Detailed Site Plan

Trinity Religious Temple Church

DSP-23014

SUBJECT: Detailed Site Plan DSP-23014
Variance to Section 27-441(b), footnote 52
Trinity Religious Temple Church

Figure 2

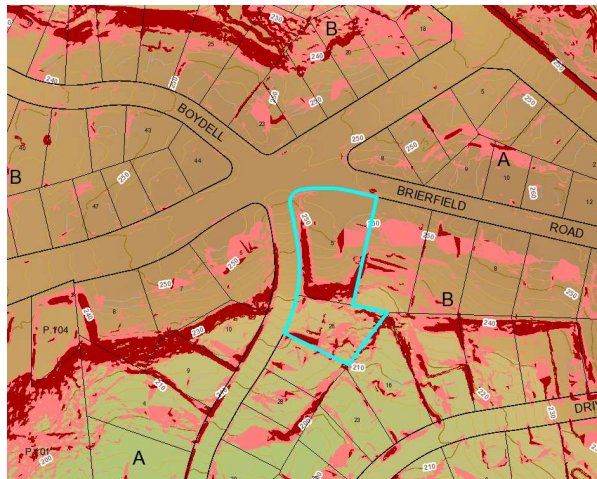
The subject property is physically unique and unusual in a manner different from the nature of the surrounding properties in terms of its exceptional topographic conditions. The northern portion of the site, Lot 5, has an elevation of 252 feet at its highest point, and approximately 230 feet at its lowest point (a difference of 22 vertical feet). In addition, the northern and southern portions of the property are separated by approximately 50 feet of steep slopes, with an elevation change of approximately 14 feet. These steep slopes continue north along the western property line along Boydell Avenue until approximately 25 feet from the front property line. This stretch of steep slopes along the western property line is approximately 25-feet wide. This condition creates two disconnected developable areas – one to the north and one to the south. In addition, the developable area on the northern portion of the property is constrained on both its south and west sides by steep slopes.

subject property. (See Figure 2 below. The dark red contour represents steep slopes.) Thus, the subject property is physically unique and unusual in a manner different from the nature of the surrounding properties.

Exhibit Showing where Variance is Needed along Rear Property Line

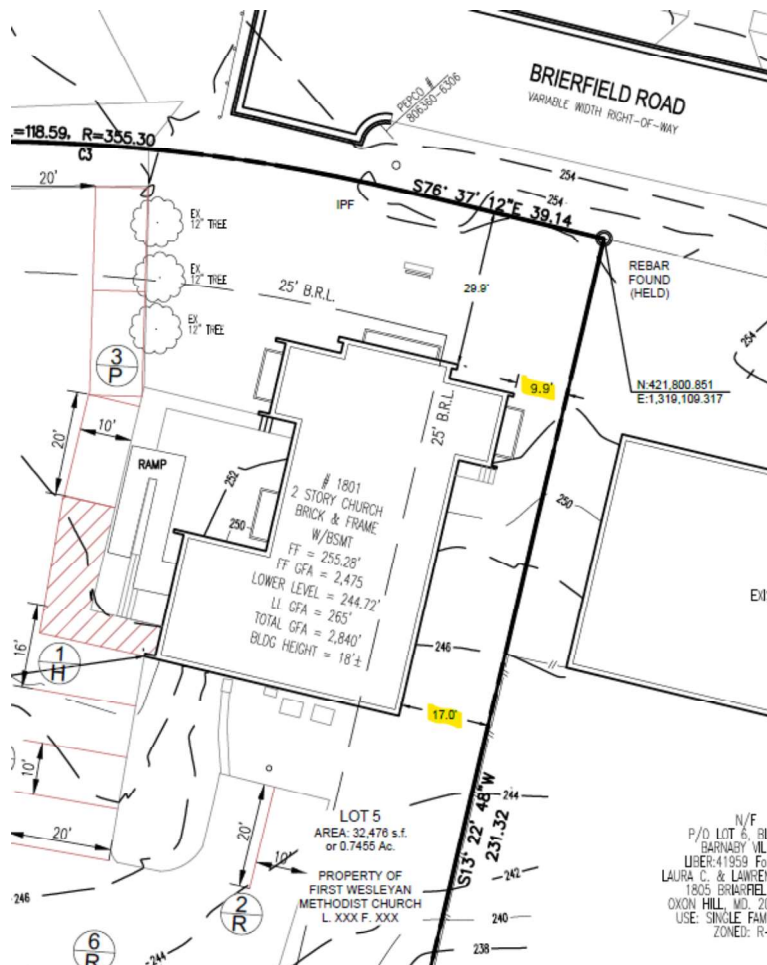
RESPONSE: The existing church building is setback 9.9 feet away from the rear property line at its closest point. As a result, a variance of 15.1 feet is requested from Section 27-441(b) - Footnote 52(A). The existing church building was constructed in 1963, and the submitted DSP proposes no expansion of the existing footprint of the building, increase in gross floor area, or increase in seat count. The sole purpose of the submitted DSP is to obtain the necessary permits needed to complete the fire restoration repairs so the existing church building can be reoccupied. As a result, the variance is the minimum reasonably necessary to overcome the exceptional physical conditions.
